REVISIONS:
1st Comments 2-24-21
2nd Comments 10-7-21

CROSSROADS CHAPEL
COLORADO SPRINGS, CO

S I T E P L A N

PCD File No PPR21-035

FINAL LANDSCAPE PLAN DETAILS & NOTES

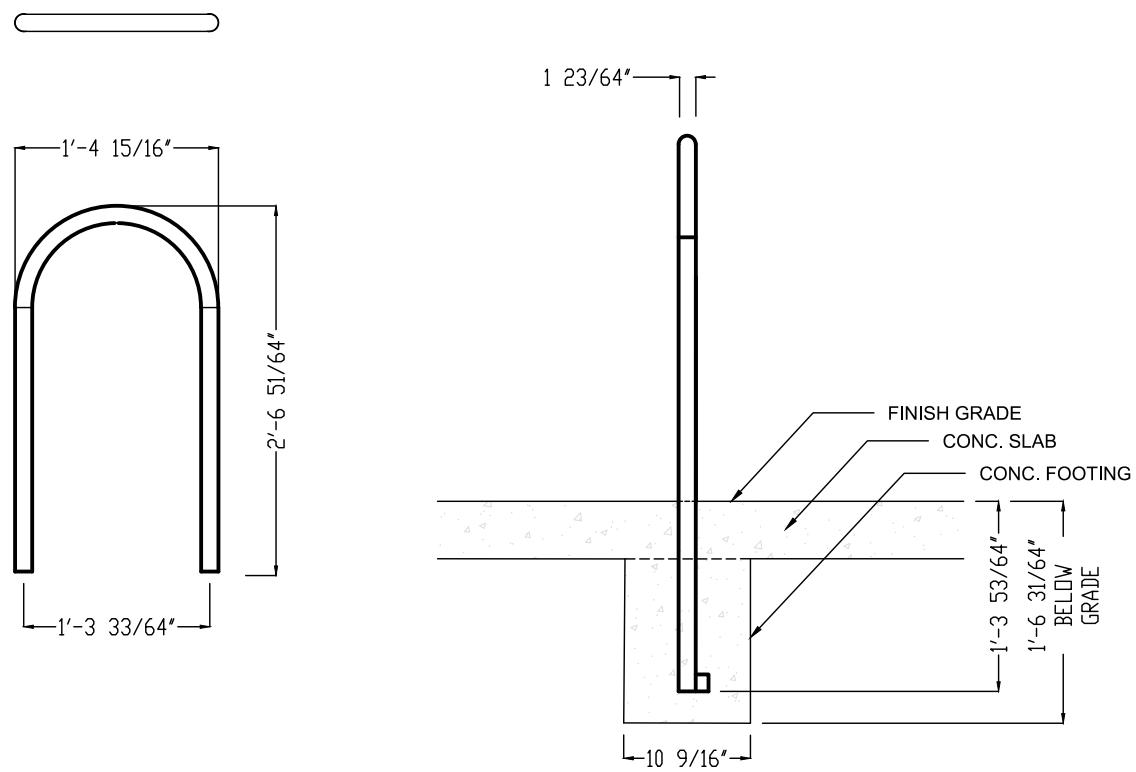
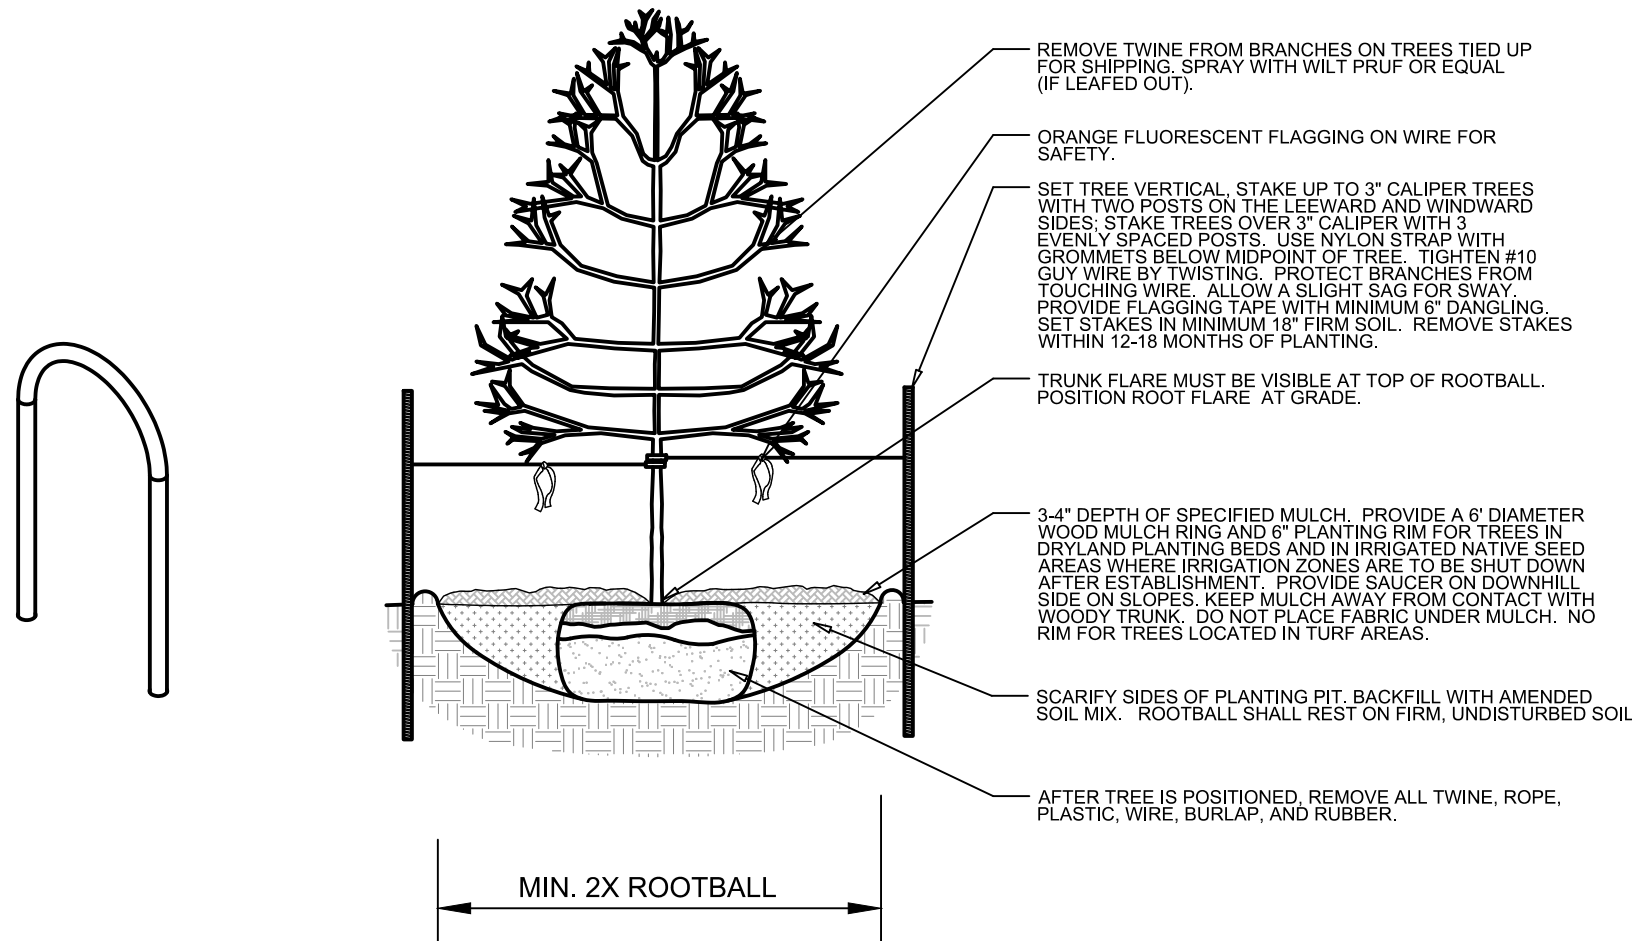
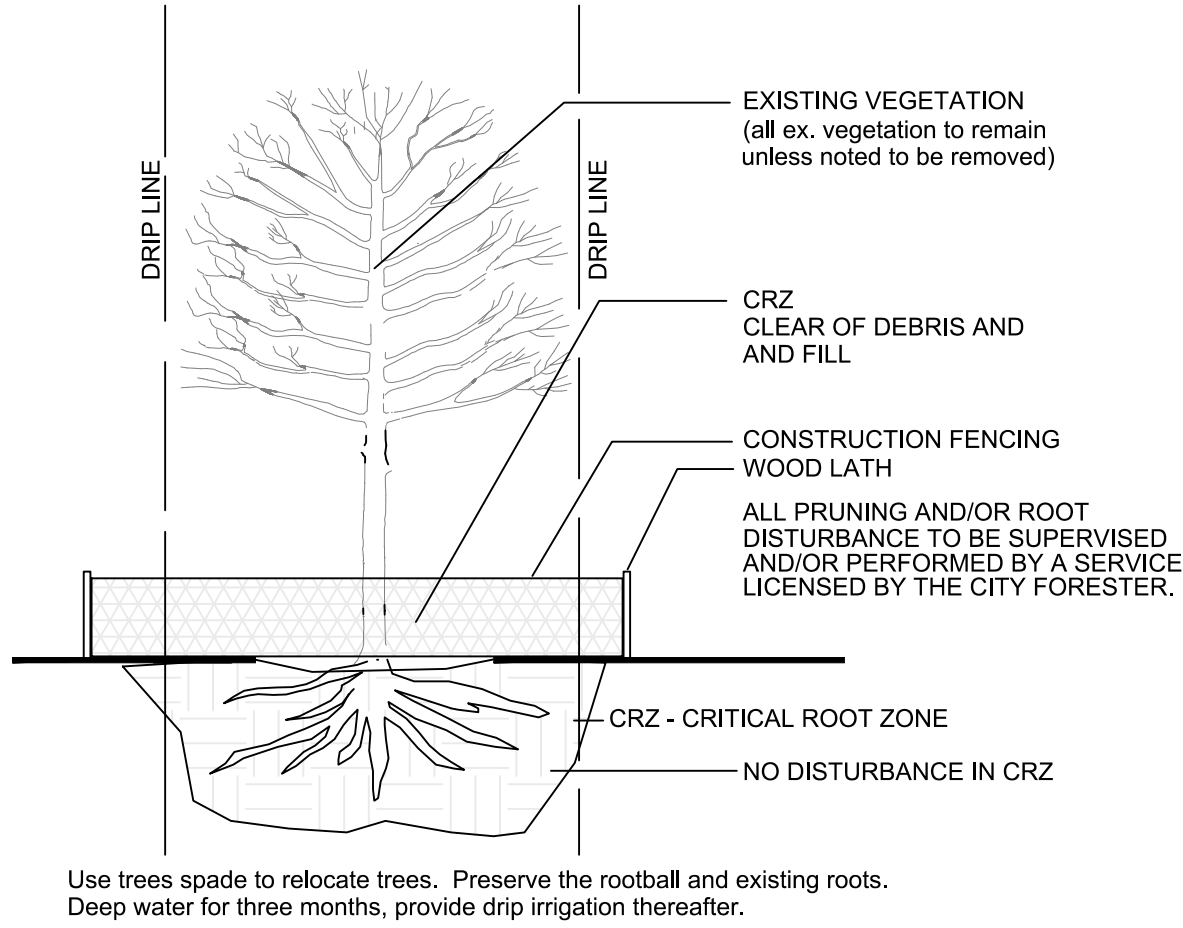
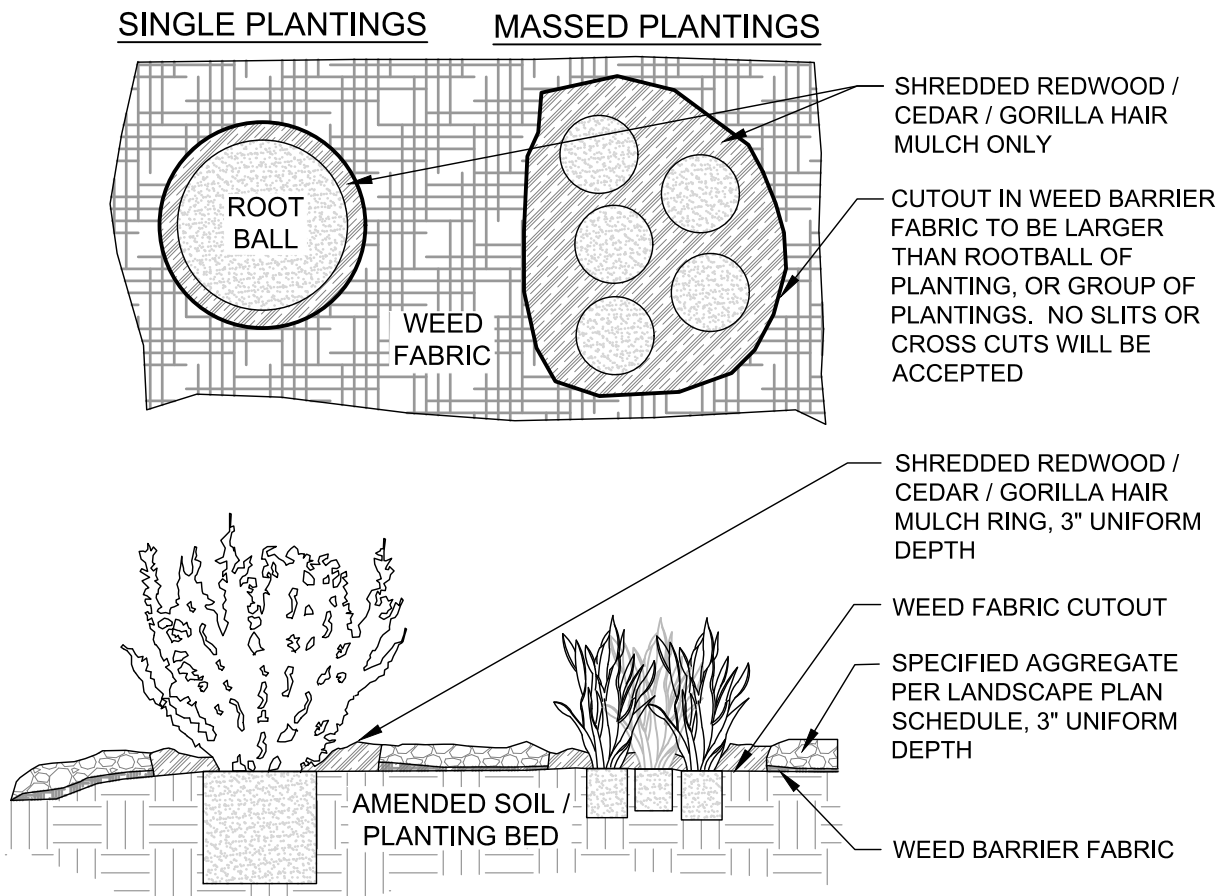
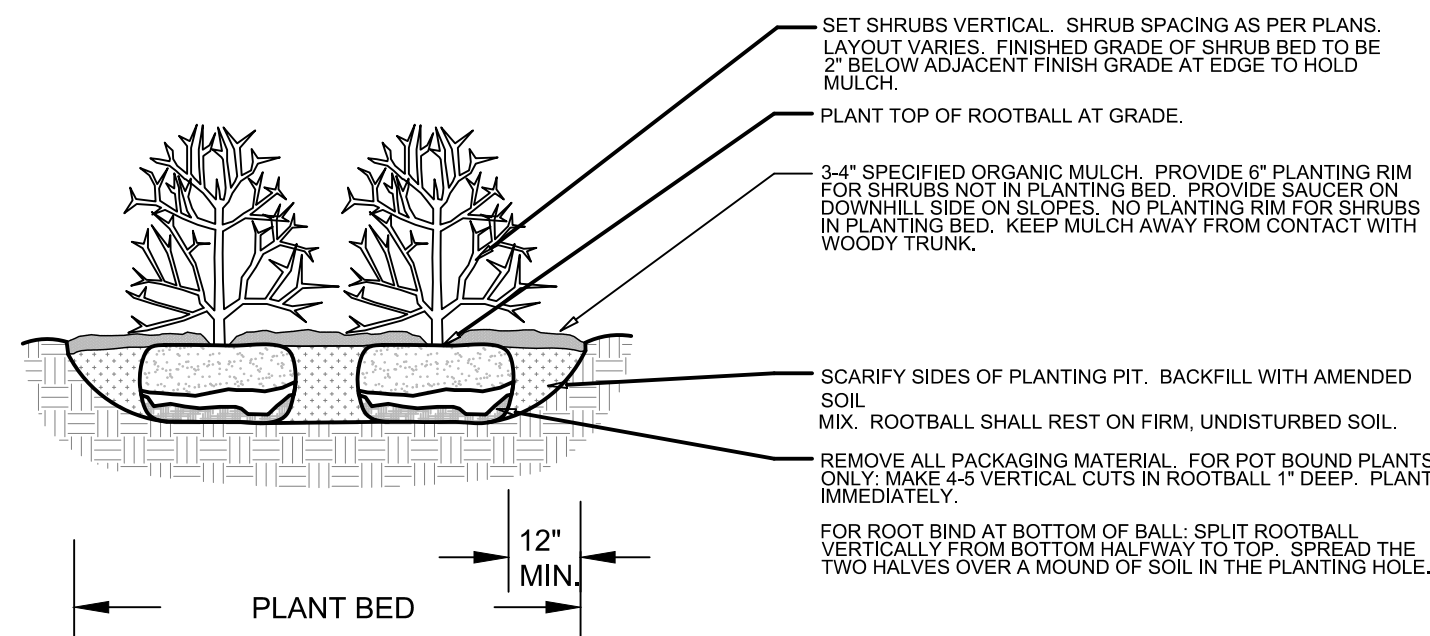
please remove landscape sheets from this document
(pages 3-5)
